Access Compliance Report

Public Rights-of-Way (Curb Ramps)

Intersection ID: 11488	Main Street: N_CHURCH_ST	Cross Street: W_12TH_ST	Location: W
ADA ID: 320EA6D5AE50	Ramp Type: Directional1	Initial Pass/Fail: Fail	Overall Compliance: No
		Severity Score: 12.5

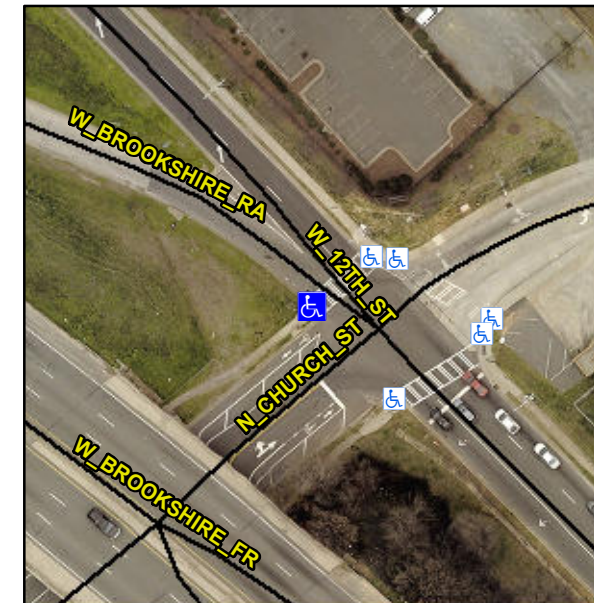
R304.2.2

Compliance	Description	Data	Compliance	Description	Data
N/A	Ramp Length (in)	109.0	N/A	Grade Break?	N/A
Yes	Ramp Width (in)	58.5	N/A	Grade Break Slope (%)	0.0
No	Ramp Slope (%)	9.6	N/A	Grade Break XSlope (%)	0.0
Yes	Ramp XSlope (%)	0.4			
N/A	Flare Type LT	N/A	N/A	Flare Type RT	N/A
N/A	Flare Slope LT (%)	N/A	N/A	Flare Slope RT (%)	0.0
N/A	Flare Traversable LT?	N/A	N/A	Flare Traversable RT?	N/A
N/A	Landing Length (in)	0.0	N/A	DWS Provided?	N/A
N/A	Landing Width (in)	0.0	N/A	DWS Contrast?	N/A
N/A	Landing Slope (%)	0.0	N/A	DWS Length (in)	N/A
N/A	Landing X Slope (%)	0.0	N/A	DWS Full Width?	N/A
N/A	Landing Curb? (Y/N)	N/A	N/A	DWS Offset LT (in)	N/A
N/A	Shared Landing?	N/A	N/A	DWS Offset RT (in)	N/A
N/A	Gutter Ponding?	0.0	N/A	Gutter Slope (%)	N/A
N/A	Gutter Lip Ht (in)	0.0	N/A	Gutter X Slope (%)	N/A
N/A	Painted X Walk1?	Yes		Road Slope (%)	2.9
	X Walk 1 Direction	To NE		Road X Slope (%)	2.2
	X Walk 1 Width (in)	125.0		Clear Space?	N/A

**Remove & Replace Entire Ramp.
Restripe Crosswalk.**
